Ross ISR Project USNRC License Application Crook County, Wyoming

RAI Question and Answer Responses Environmental Report Docket #40-09091

Prepared by:
Strata Energy Inc.
1900 W. Warlow Drive, Bldg A
PO Box 2318
Gillette, WY 82717-2318

MARCH 2012

Date	Description																		
Date	Description																						
ER RAI RESPONSE FIGURE ER RAI CI-2-1 EXISTING AND POTENTIAL MINERAL DEVELOPMENT PROJECTS WITHIN 80 KM OF THE ROSS PROJECT AREA		Drawn By: MBM Checked By: JWF Date: 3/27/12

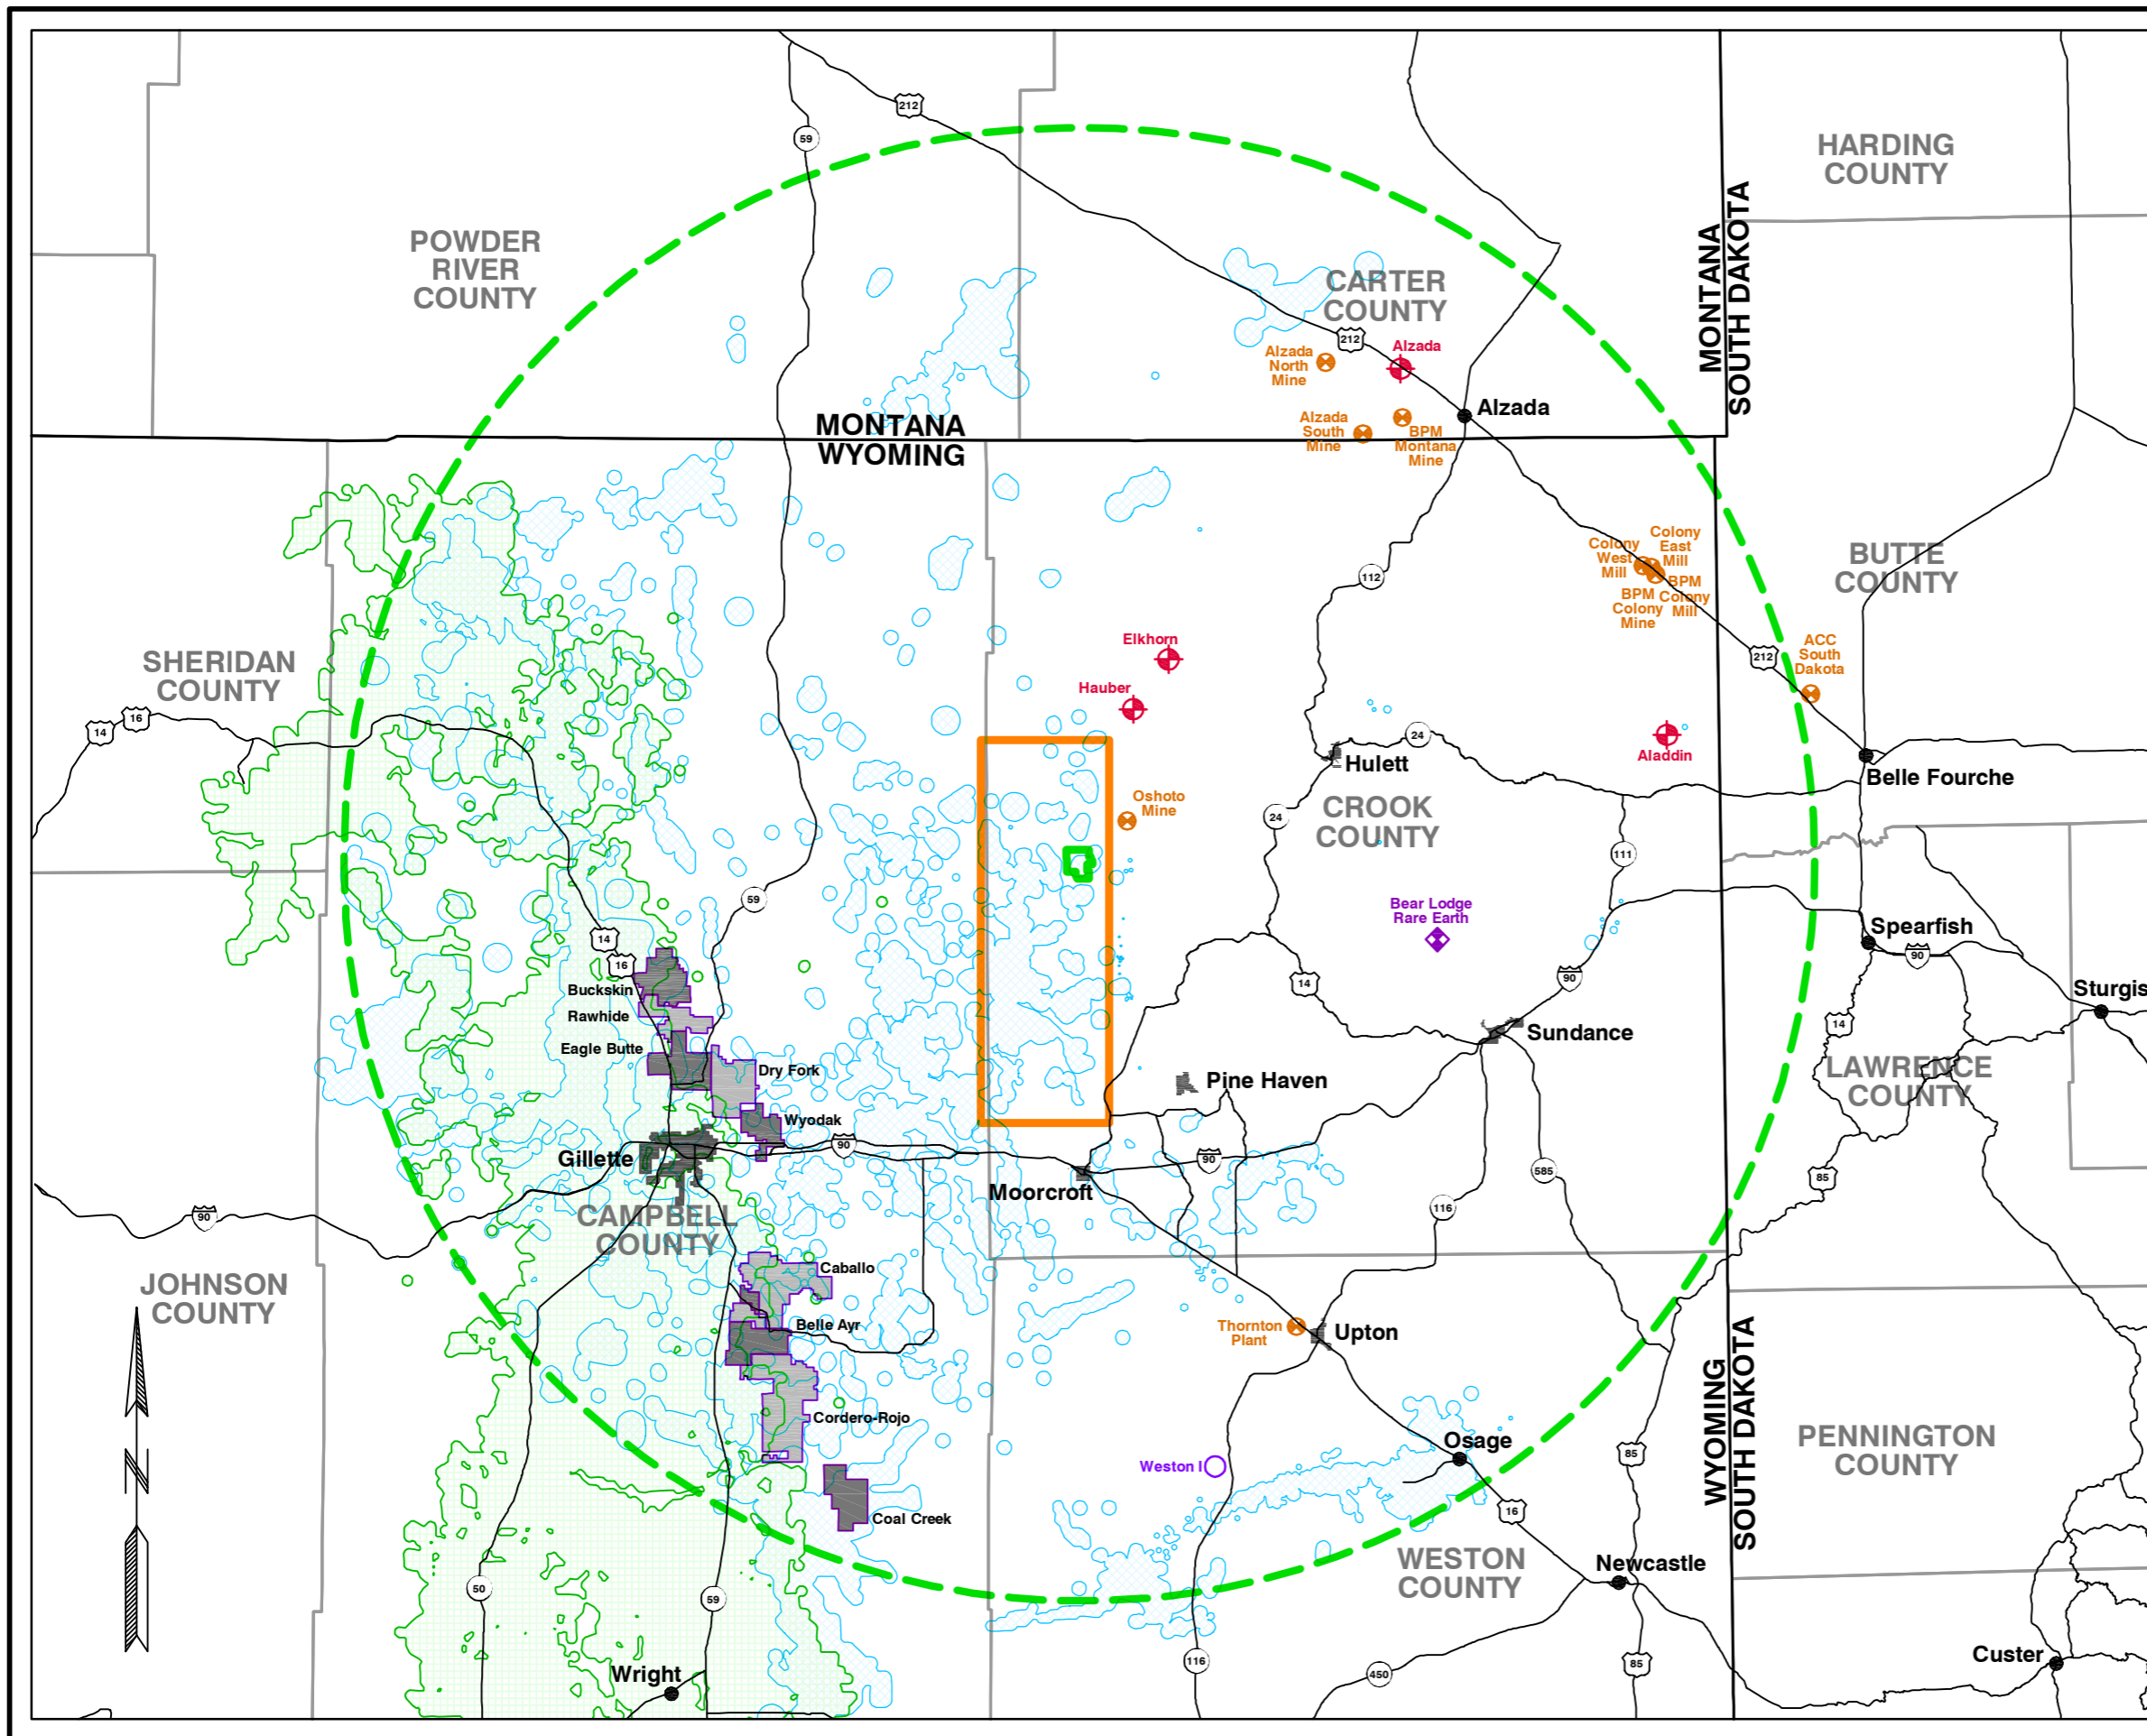
In order to assess the cumulative impacts of local, adjacent, and/or nearby operations, those operations must first be identified (in more detail than what is presented in Section 2.2.7 of the ER). For example, if another facility whose purpose is to retrieve other underlying mineral resources is to be constructed and operated in or near the Lance District, then Strata's Proposed Action could compete with the nearby operation for local workers, a socioeconomic cumulative impact. In addition, if there are other facilities near the Ross Project site, the total increase in traffic that would be associated with the construction and operation of the nearby facilities could cause cumulative impacts to transportation. Thus, it is important to identify and describe any current and anticipated projects that may cumulatively impact resources anticipated to be impacted by the proposed Ross Project. The assessment of cumulative impacts is conducted under the authority of 10 CFR Part 51.

Figure ER RAI CI-2-1 depicts the current and potential projects included in the cumulative impact analysis.

Figure ER RAI CI-2-1 shows the location of active coal mines in relation to the Ross ISR Project. Within a 50-mile radius of the Ross ISR Project there are nine active coal mines. The owners and locations of these mines in relation to the Ross ISR Project are provided in Table ER RAI CI-2-1.

Figure ER RAI CI-2-1 depicts existing oil and gas fields and coal bed natural gas (CBNG) fields within 50 miles of the proposed Ross project area (DOE 2012a, 2012b). As described in ER Section 2.2.7.2.3, there are three producing oil wells, two water injection wells, and three water supply wells used for enhanced oil recovery within the proposed Ross project area. Mitigation measures for potential impacts to the enhanced oil recovery water supply wells are described in ER Section 5.4.2.1.2 (pg. 5-36) and include working with the oil production company to temporarily provide an alternate water supply or alternate means of enhanced oil recovery. See also the response to TR RAI 18 in the TR RAI response package, which describes how Strata is currently working with Merit to discontinue use of their water supply wells within the proposed Ross project area prior to ISR operations. The density of oil and gas development is typical of the region as shown on Figure ER RAI CI-2-1. No CBNG well fields are within the proposed Ross project area due to its location stratigraphically below the Wasatch and Fort Union formations where the CBNG production occurs (refer to ER Section 2.2.7.3).
